WEST FACADE.
SJB ARCHITECTS N.T.

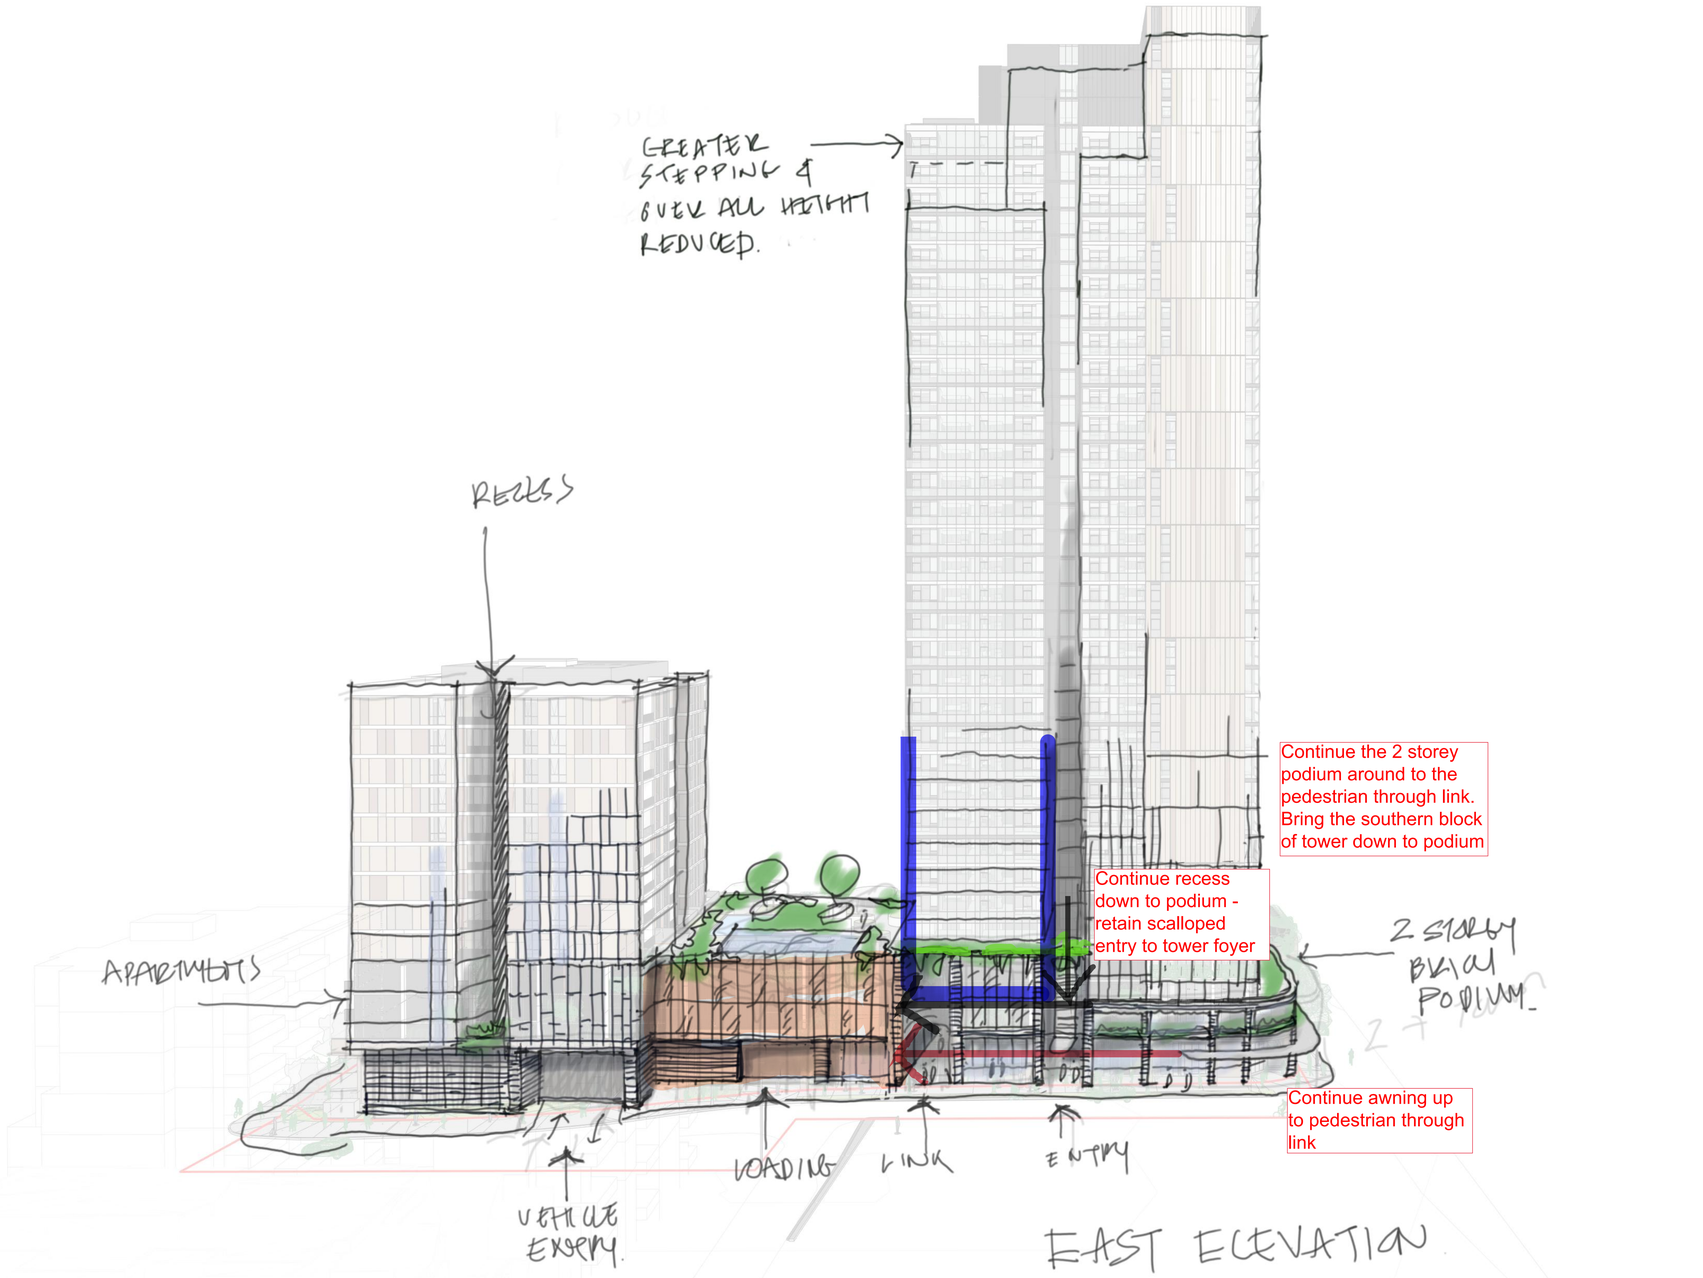
GREATER STEPPING & OVER ALL HEIGHT REDUCED.
RECESS
APARTMENTS
Continue the 2 storey podium around to the pedestrian through link. Bring the southern block of tower down to podium
Continue recess down to podium - retain scalloped entry to tower foyer
2 STOREY BRICK PODIUM
Continue awning up to pedestrian through link
VEHICLE ENTRY
LOADING
LINK
ENTRY
EAST ELEVATION

STAGE 2-
FUTURE DEVELOPMENT
AWNING
AWNING
13 RESIDENTIAL (4 TANDEMS)
STORAGE / PLANT
AWNING
LEVEL 01
EXISTING 8 STOREY
BUILDING

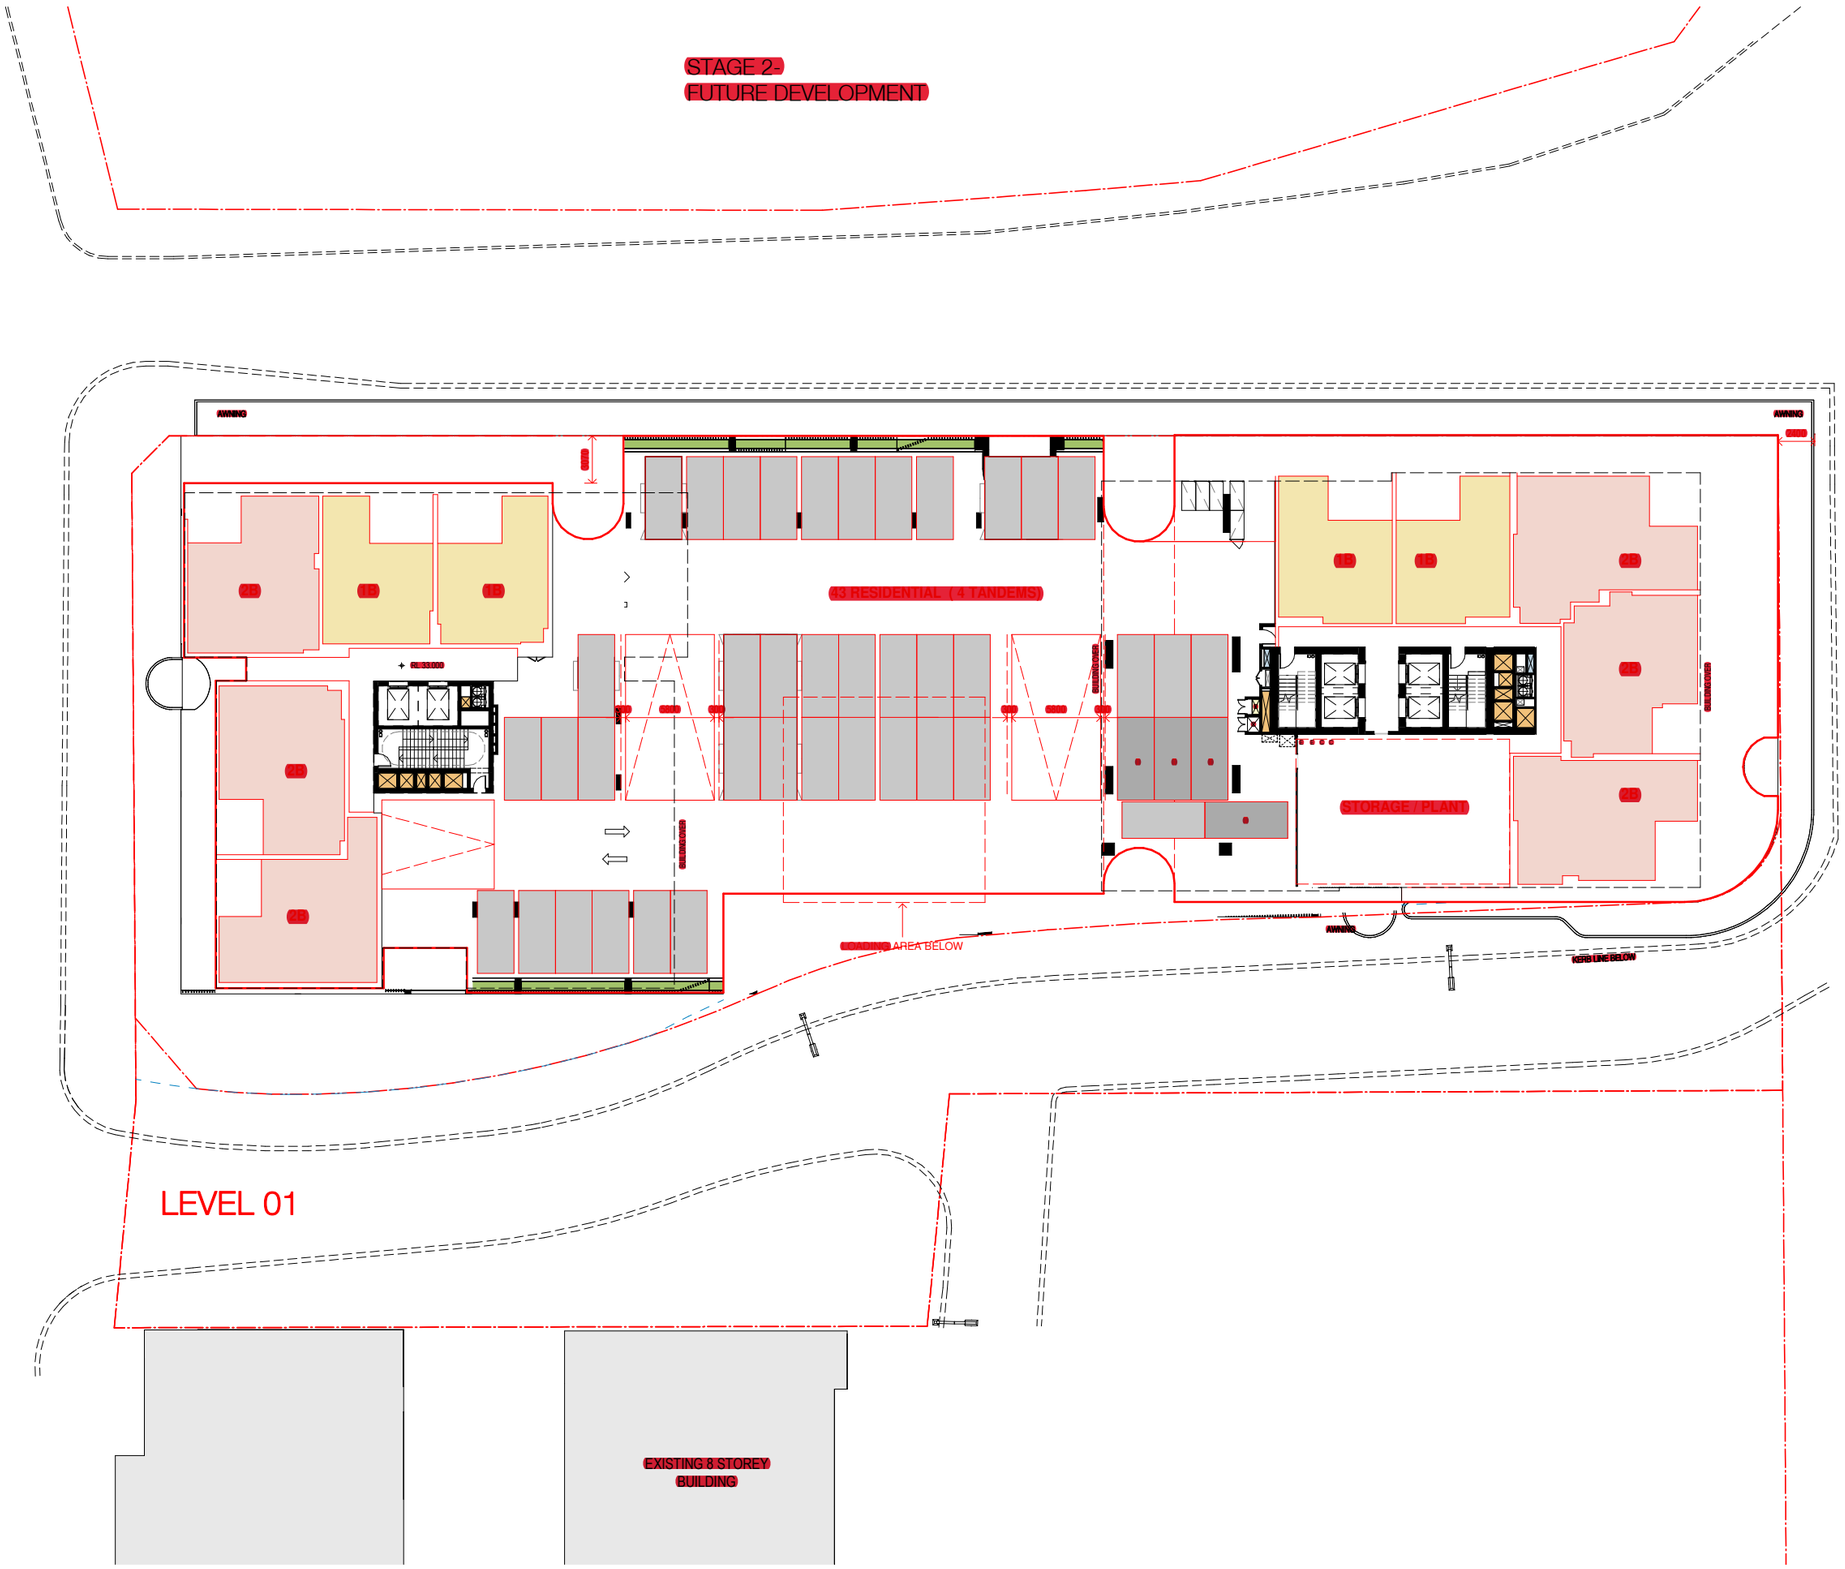
Provide a high quality transition space between carpark and sleeved apartment foyer - floor/wall/ceiling finish and special lighting - perhaps contained with a glazed airlock.
